NOTICE OF ERROR
REPLY

Water right number: 37-494

Re: Notice of Error-Water Rights Valley Club Inc.
37-2623, 37-494, 37-657B, 37-495, 37-833K, 37- 0577BU, 37-057BV

VALLEY CLUB II
2006 Irrigation calculation
NAIP 2006 Aerial photo

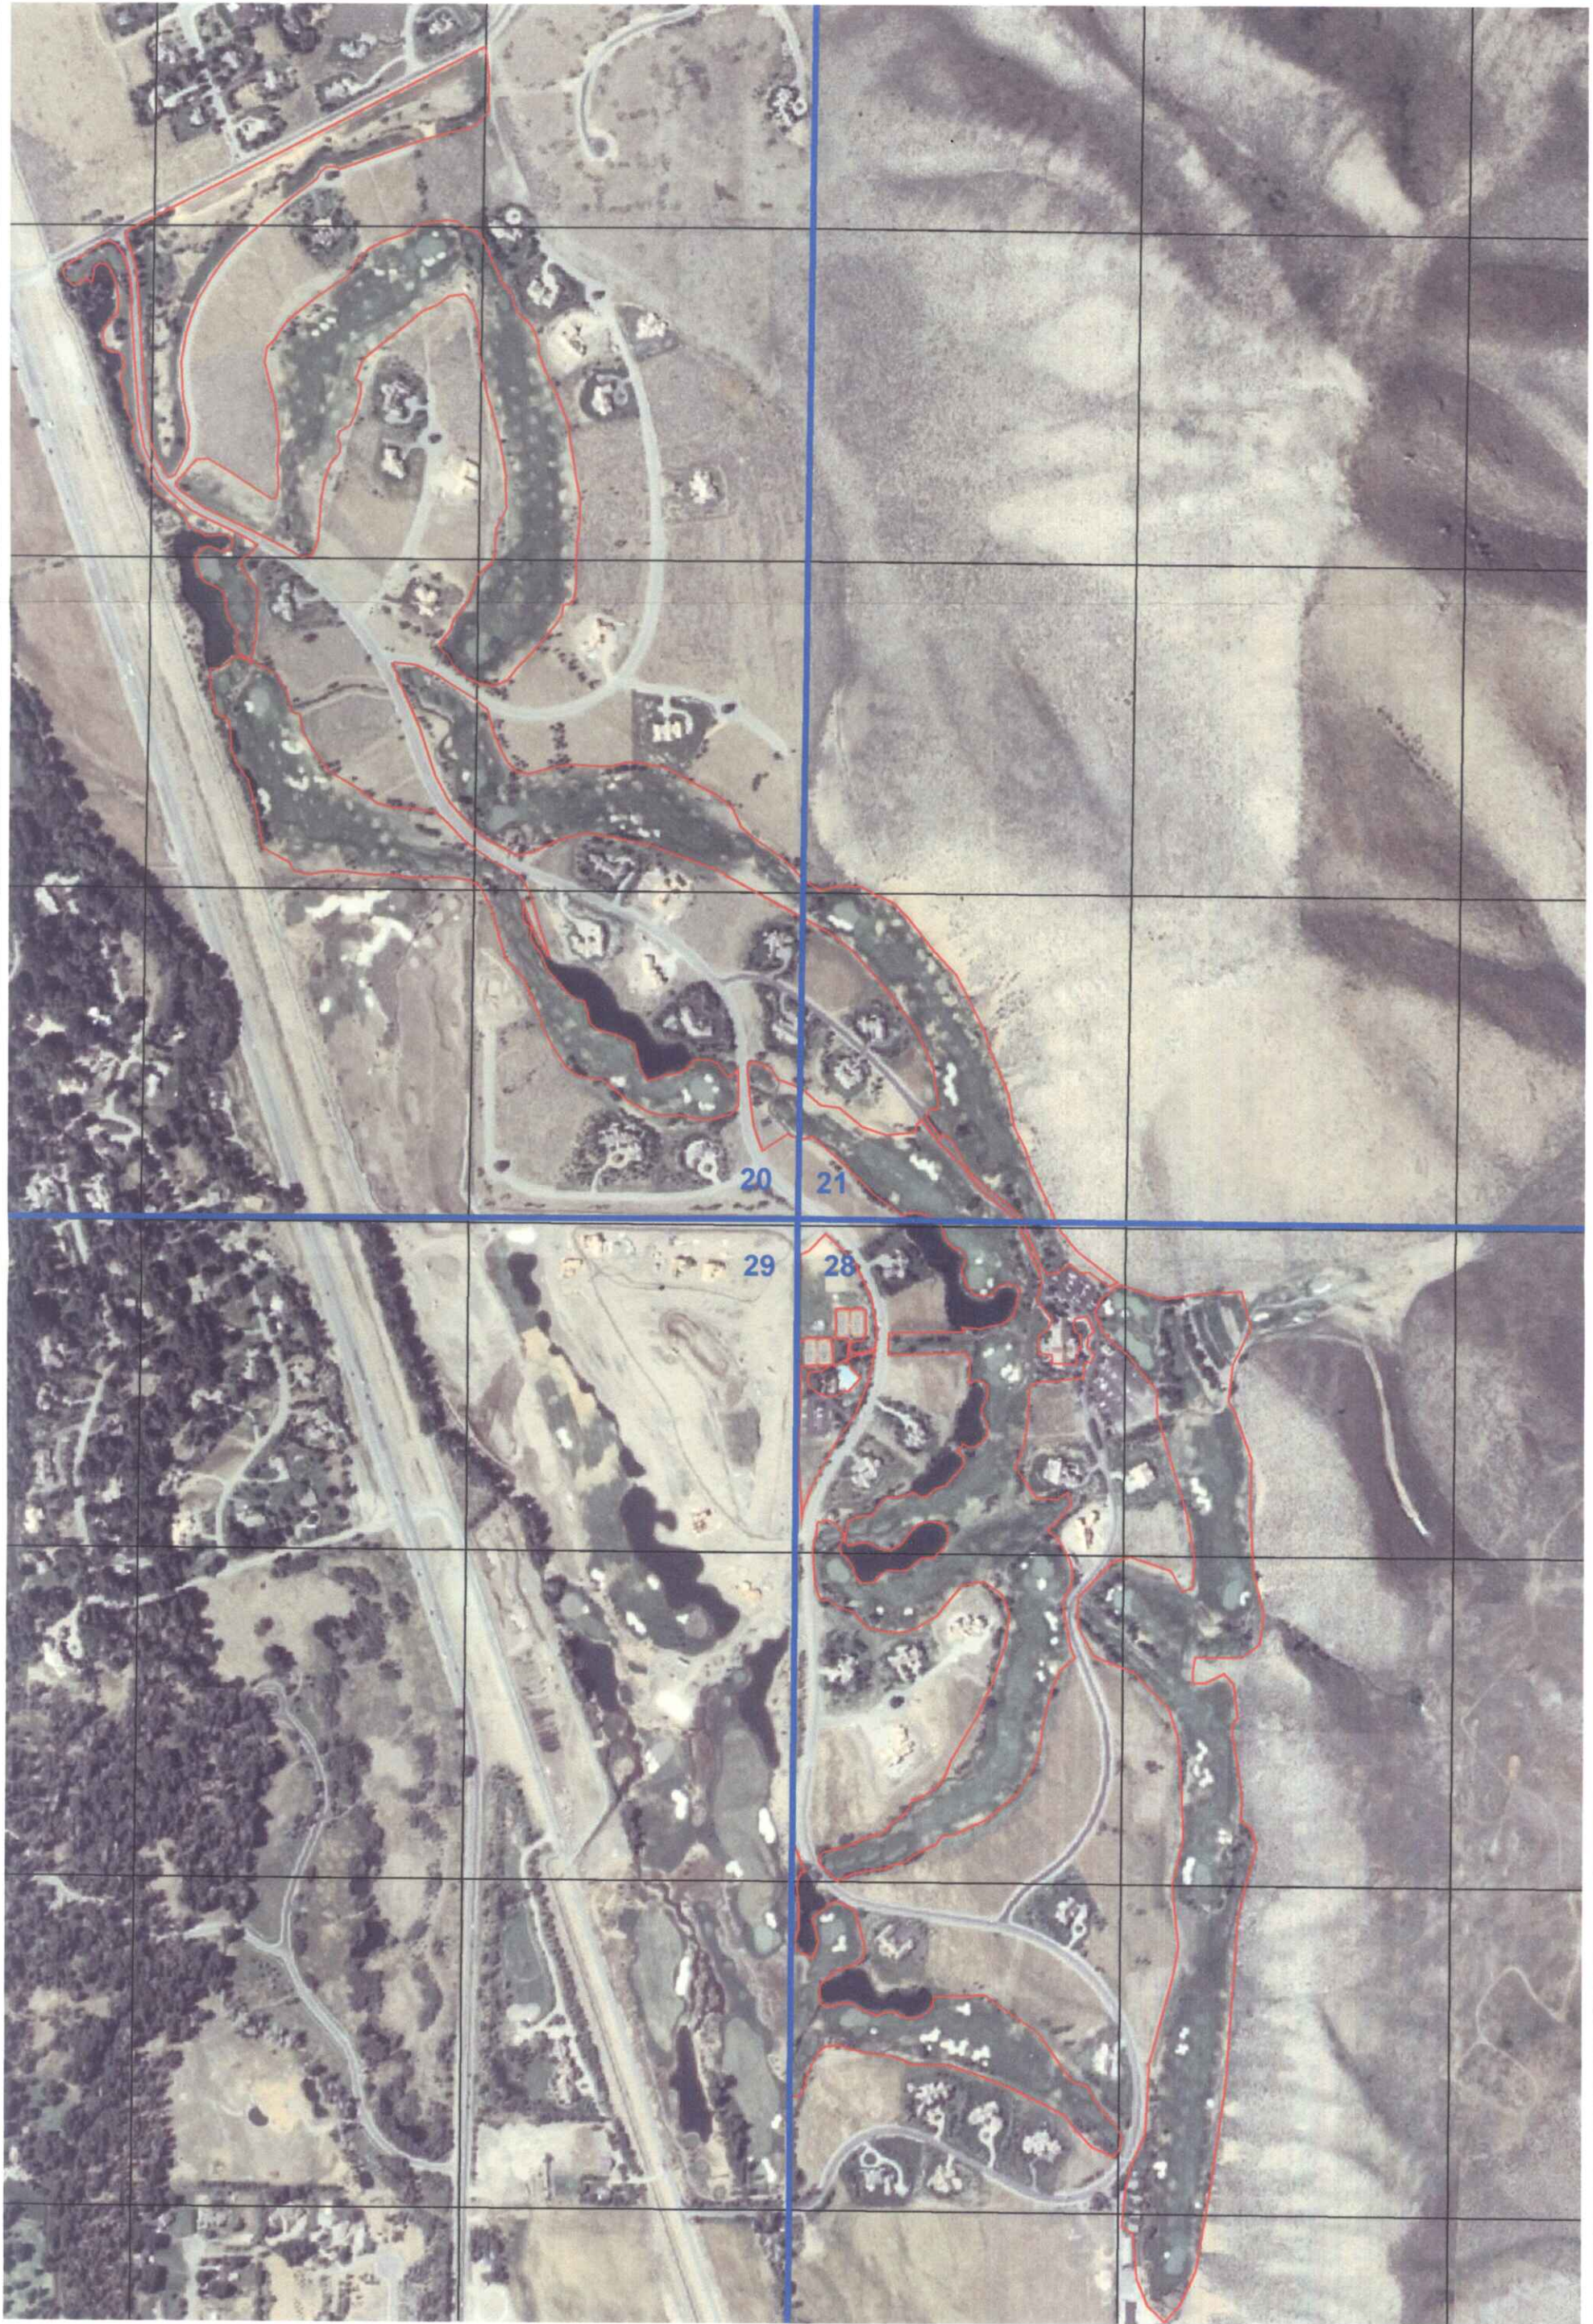
*Recommended acreage of 120.7 ac
should be 143.8 ac.*

IDWR - SHP file is incorrect

Sum = 144.6 acres
Claim = 143.8 acres
Pre. Rec.= 120.7 acres
